MARK	DATE	DESCRIPTIONS	BY	CH'D	CCO#
0	05/06/11	MEP INTEGRATION REV. & UPGRADES TO SYSTEMS	TW	RG	163

CONTRACT CHANGE ORDER NO. 163
SHEET 3 OF 32

SKYWAY ROADWAY LEVEL EASTBOUND LIGHTING AND ELECTRICAL SYSTEMS

DETAIL 1 - ELEVATION

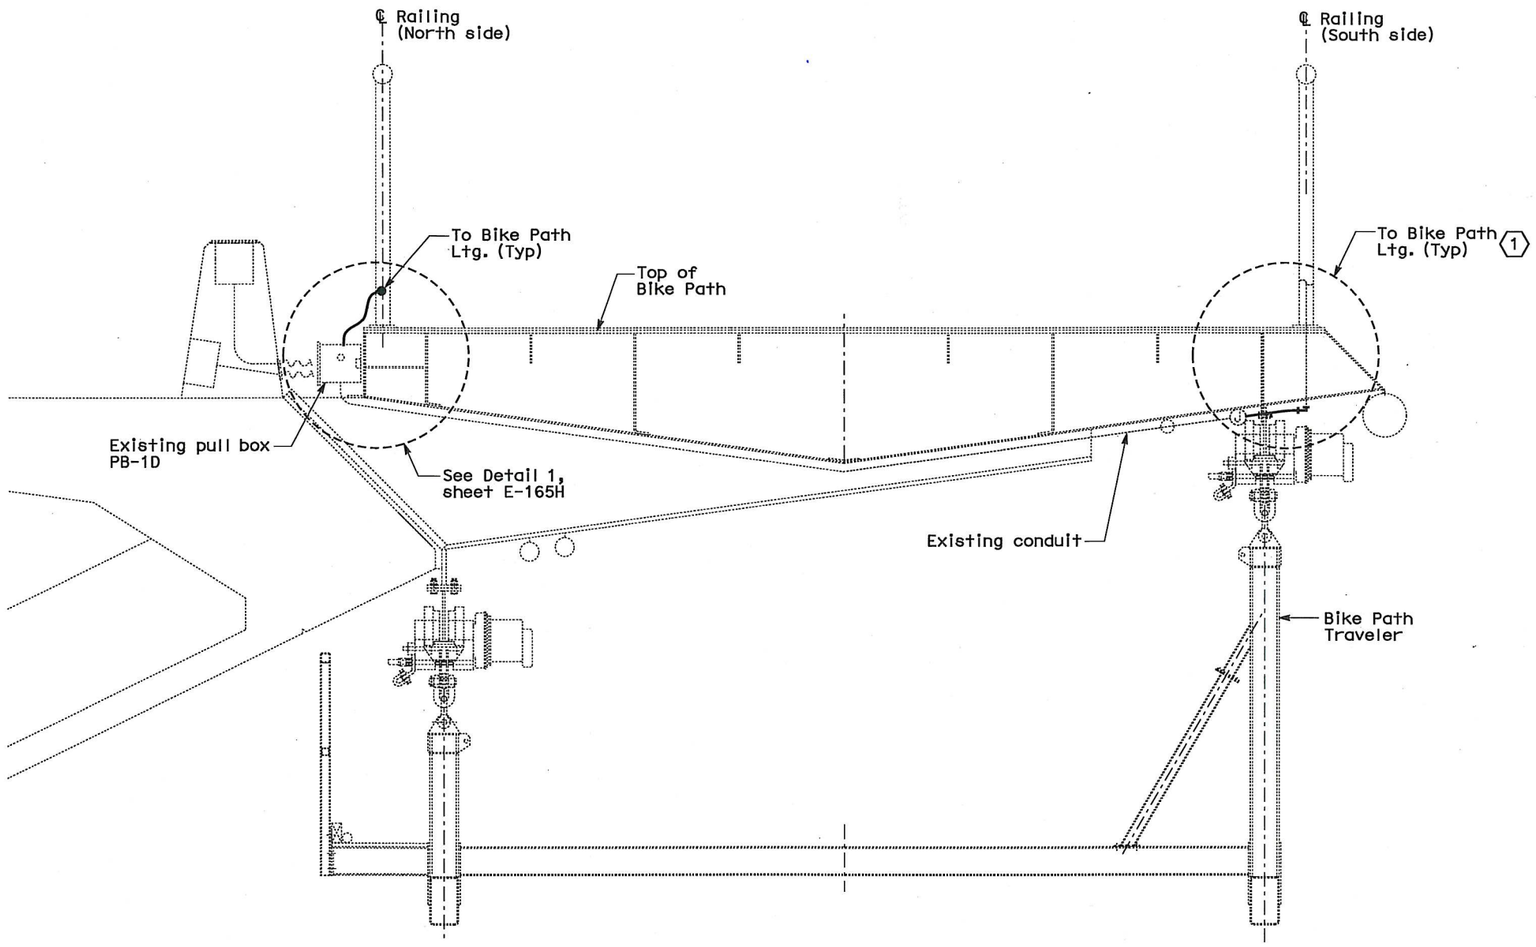
1 For bike path light detail, see Sheet E-165J.

DETAIL 1 - ELEVATION

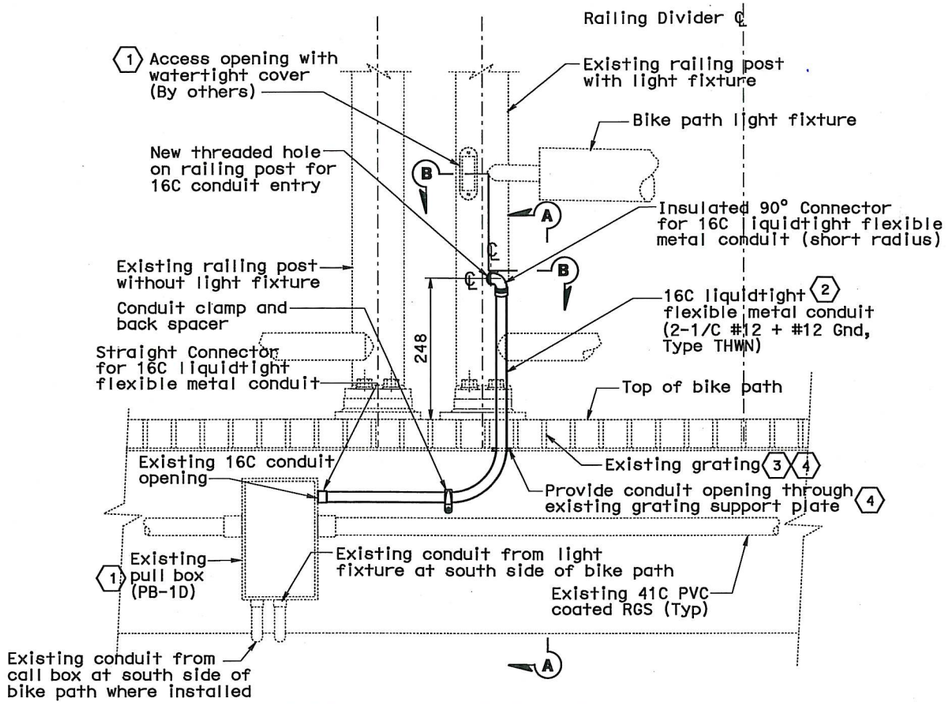
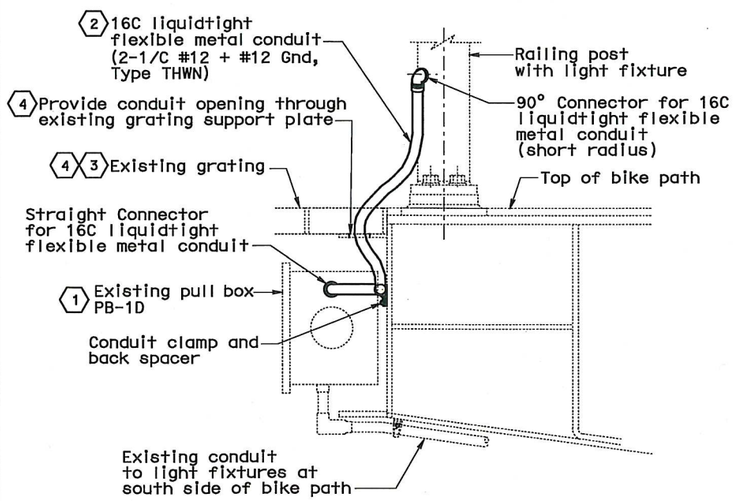
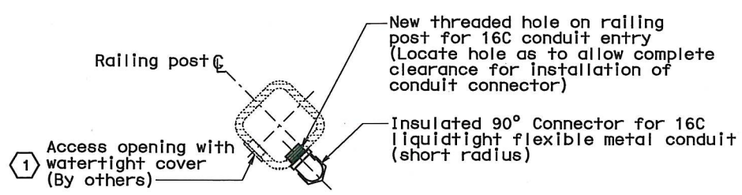
1. Disconnect and remove existing bike path lighting conduits, JB and wires at both ends. Plug unused holes on pull box PB-1D.
2. Install a new 16C Liquidtight flexible metal conduit between the railing post and existing pull box (PB-1D). Install and connect new conductors to light fixture and splice to existing conductors inside PB-1D.
3. Where required, provide cutout opening on grating for the new conduit. Grating must be able to be removed without disconnecting the conduit or electrical wires from the light fixture.
4. Contractor shall restore all surface areas of steel plates and gratings that have been cut or where finish coating has been removed or damaged. Restoration shall be performed in accordance with the applicable specification.

DETAIL 1
CONDUIT PENETRATION DETAIL

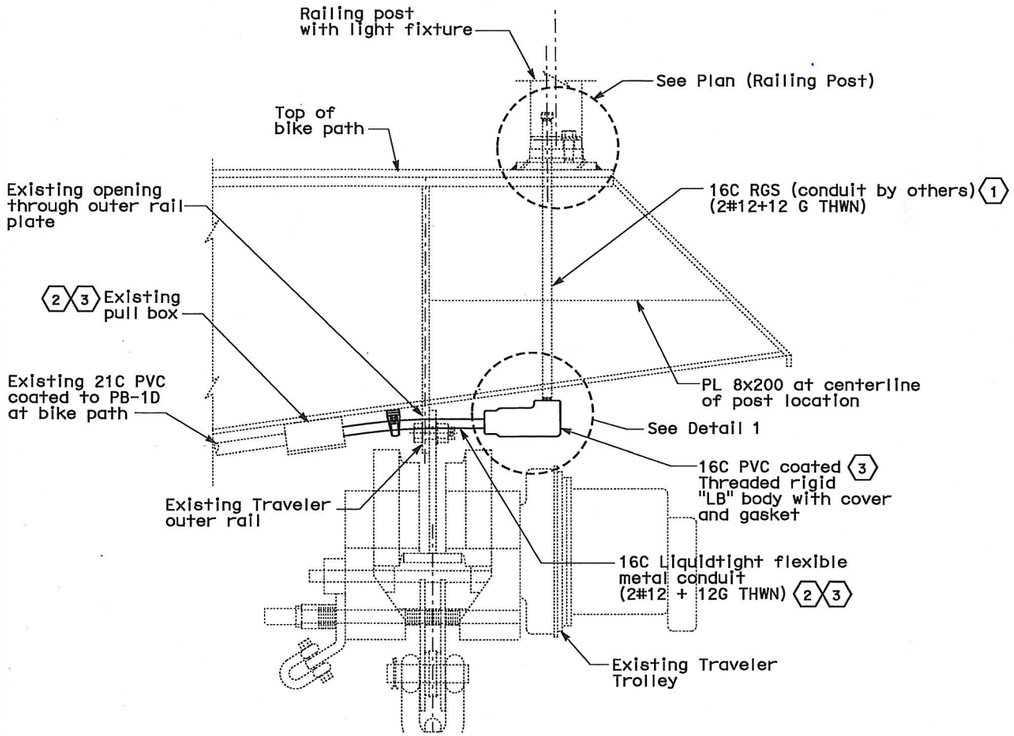
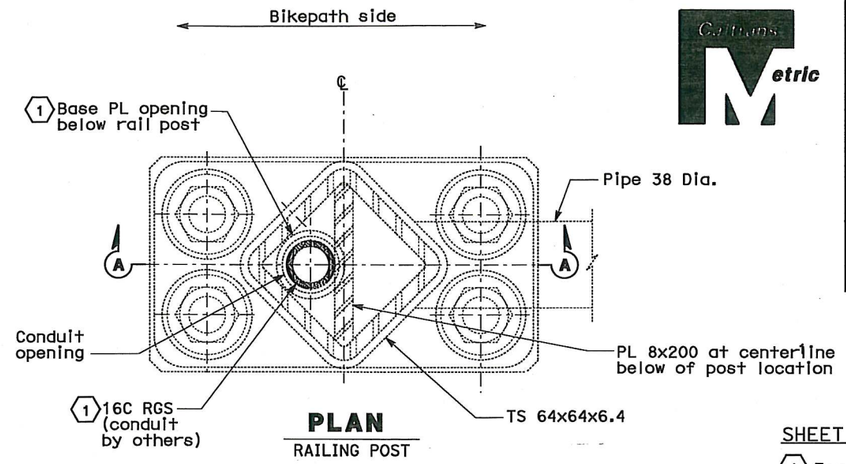
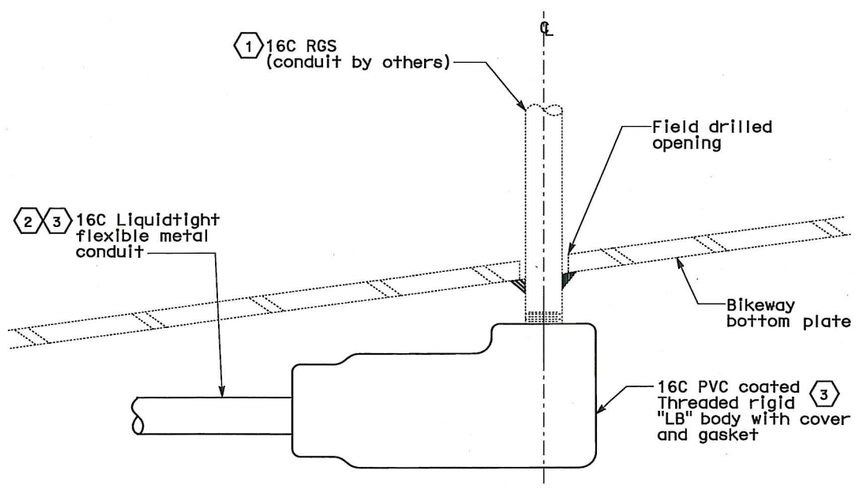
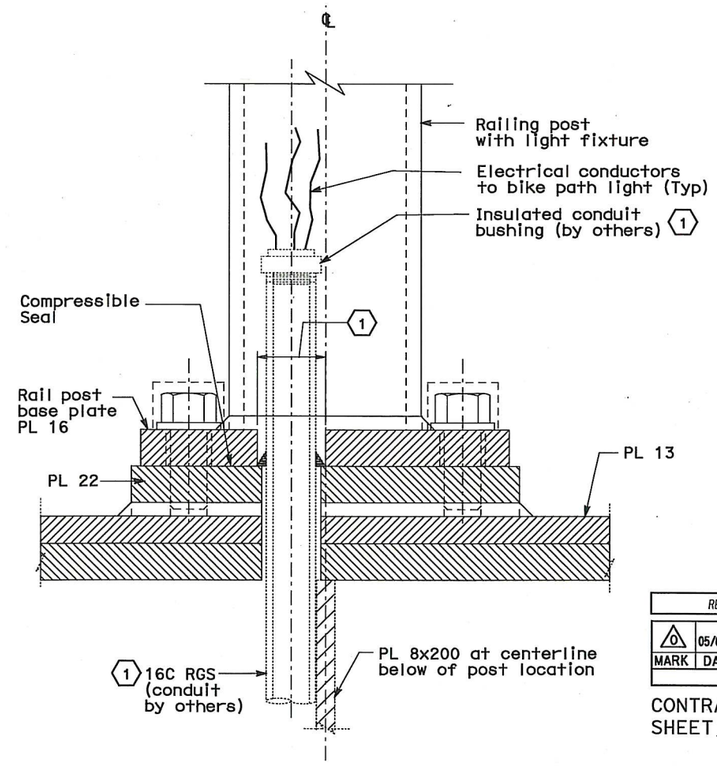
(1) For conduit installation and opening, see Structural Plans.

(2) Disconnect and remove existing RG conduits and cables intended for bike path lighting from existing pull box.

(3) Install new 16C Liquidtight flexible metal conduit route through existing Traveler outer rail plate between existing pull box and new 16C PVC coated threaded rigid "LB" body. Connect "LB" body to existing 16C RGS (conduit by others). Install new conductors and splice (2#12 + 12G THWN) from existing pull box to bike path railing post via existing conduit.

DETAIL 1 - ELEVATION

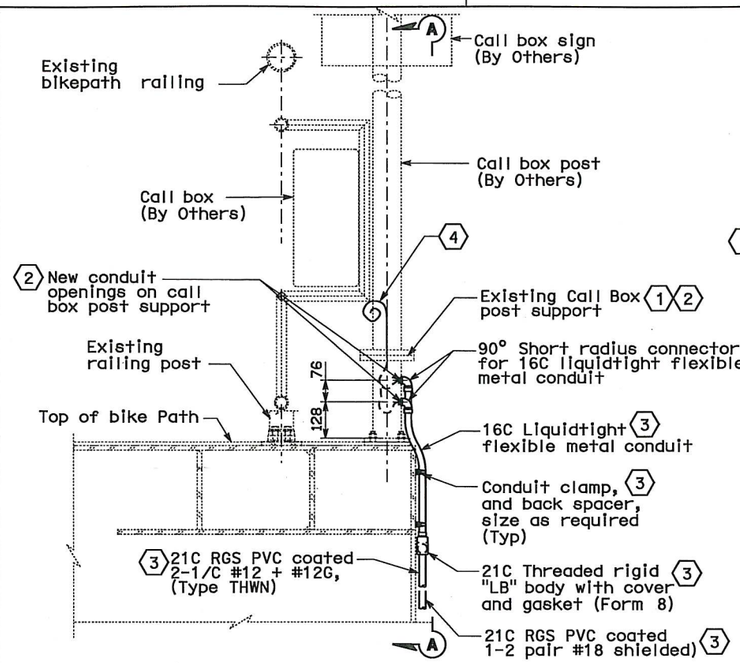
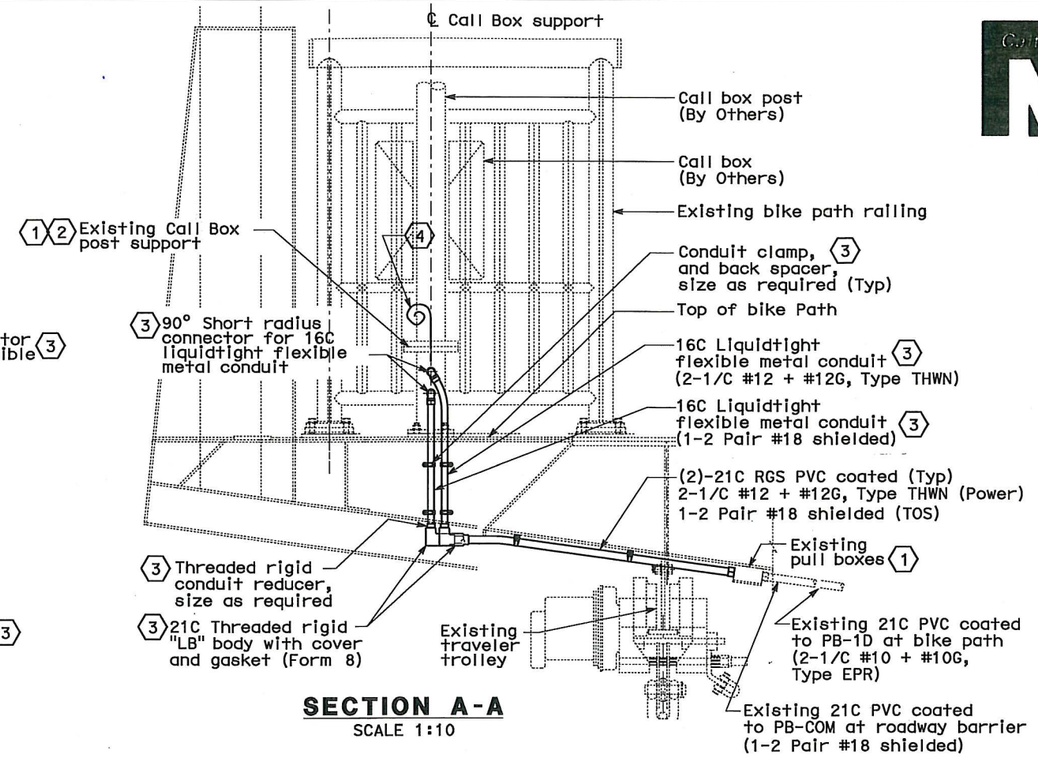
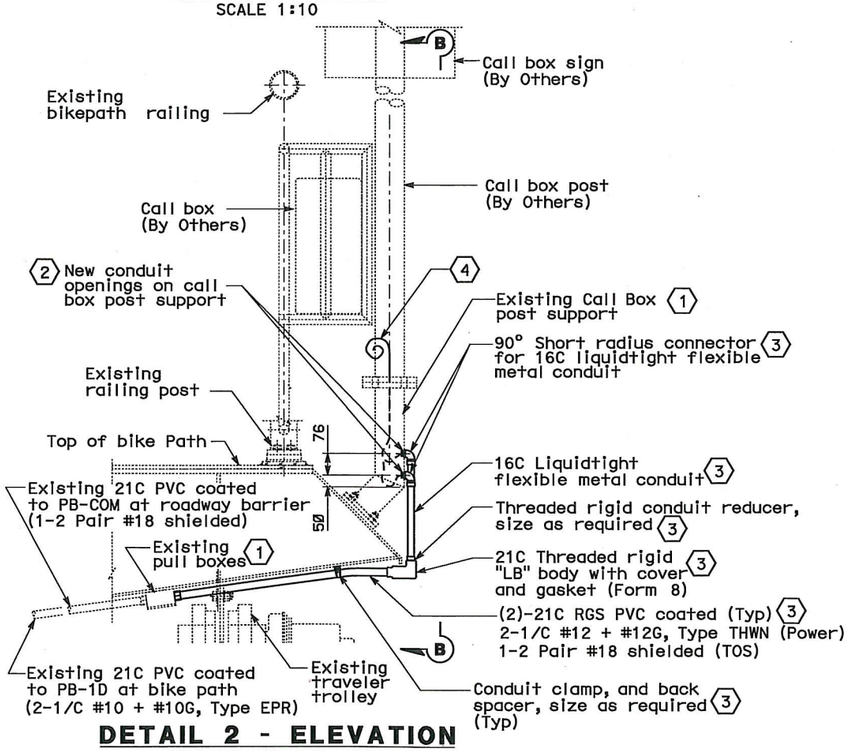
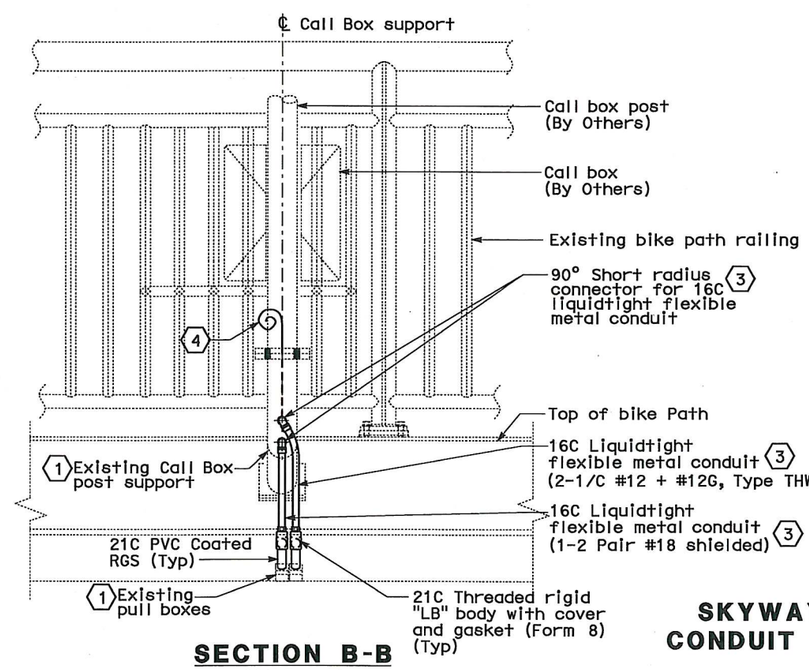
1. Disconnect and remove existing liquidtight flexible metal conduits intended for lighting and Comm. cables between the call box post support and the existing pull box below the bike path girder. Pull back and salvage existing conductors for future use.

2. Provide new threaded holes for 16C liquidtight flexible metal conduit on existing call box post support. Plug existing conduit openings using stainless steel threaded plugs.

3. Install new conduits and fittings between the call box post support and the respective existing pull boxes (lighting and comm.) located below the bike path girder.

4. Contractor shall inspect existing conductors for damage prior to repulling the conductors. Replace damaged conductors with the same type and size. Contractor shall also verify and ensure that there is sufficient length of lighting and Comm. conductor pigtails for future termination to the call box. Seal each conductor end to prevent water from entering the insulation. Pigtails shall be coiled and protected from damage. Provide weatherproof covers for the pigtails and call box supports.

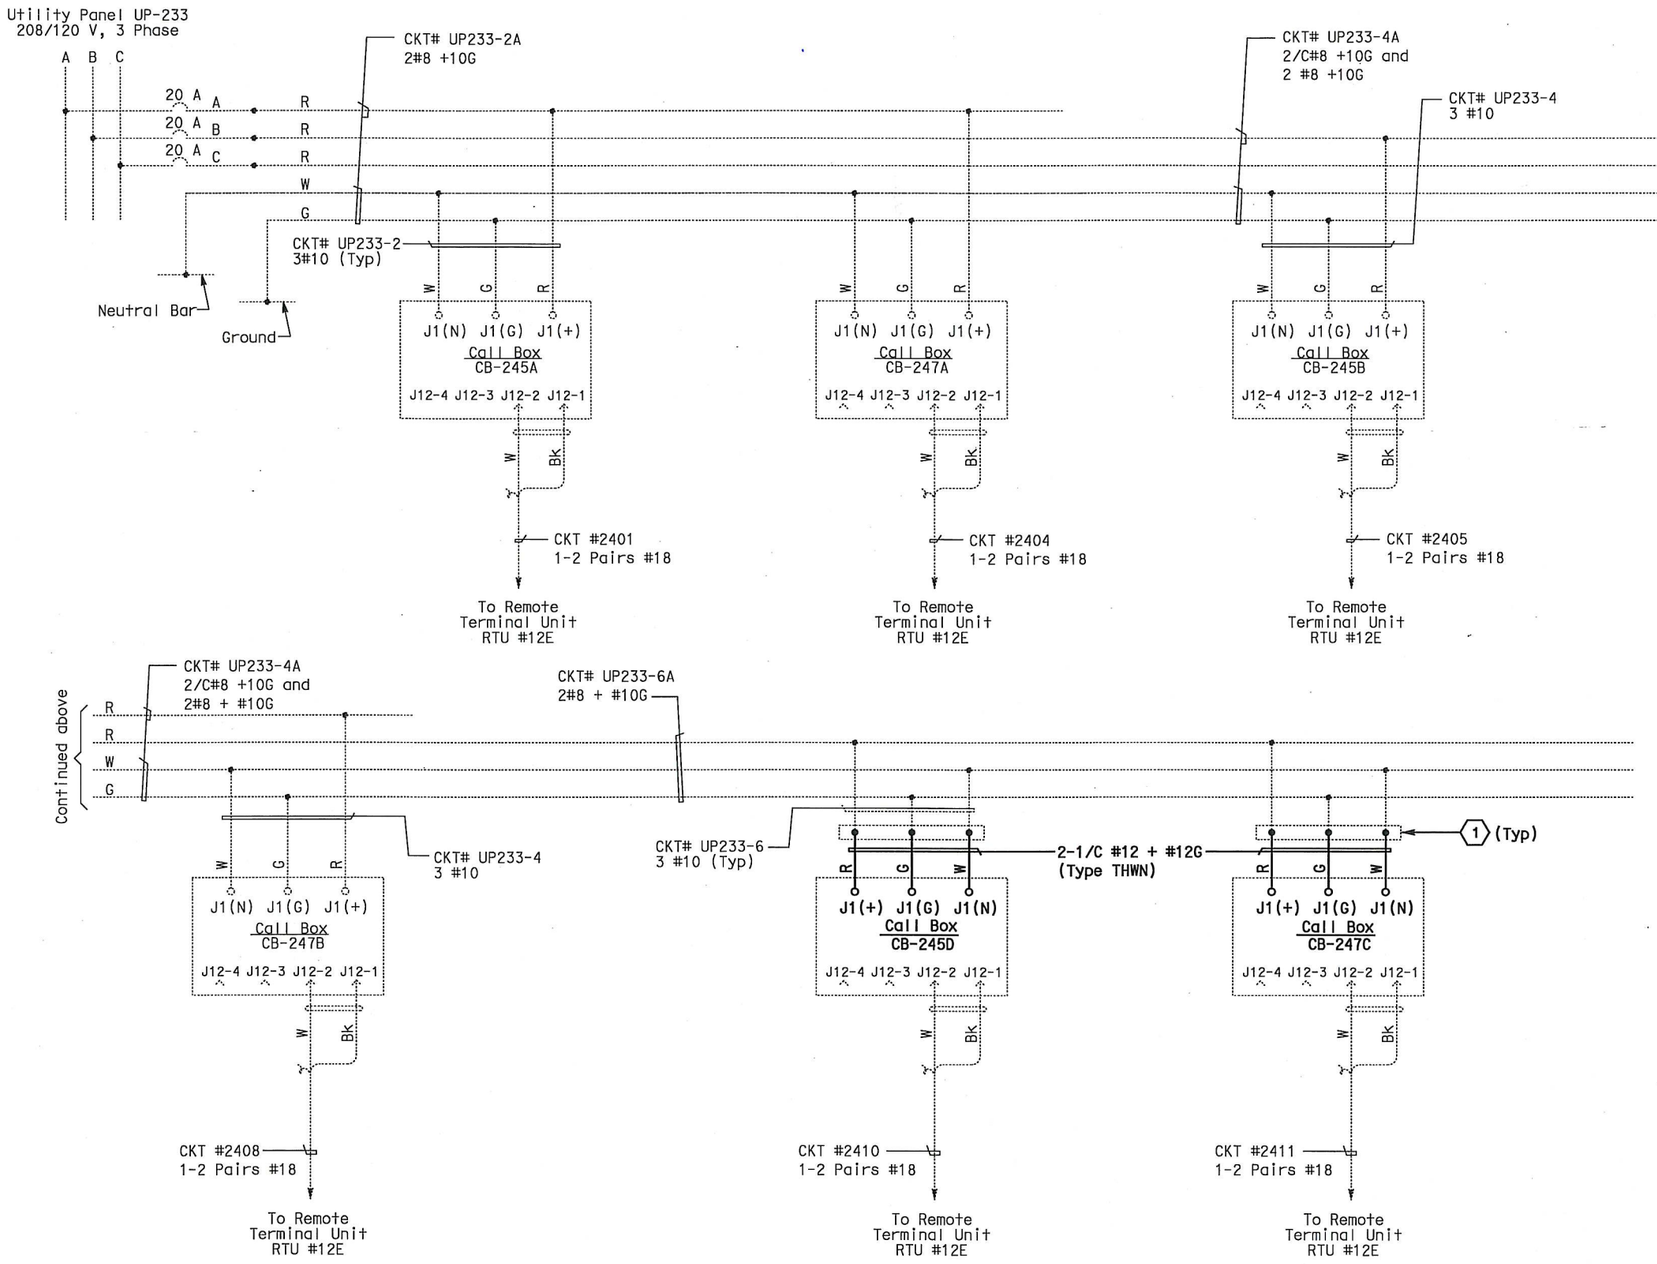
(1) Existing pull box mounted below bikepath. See Details on sheet E-165L.
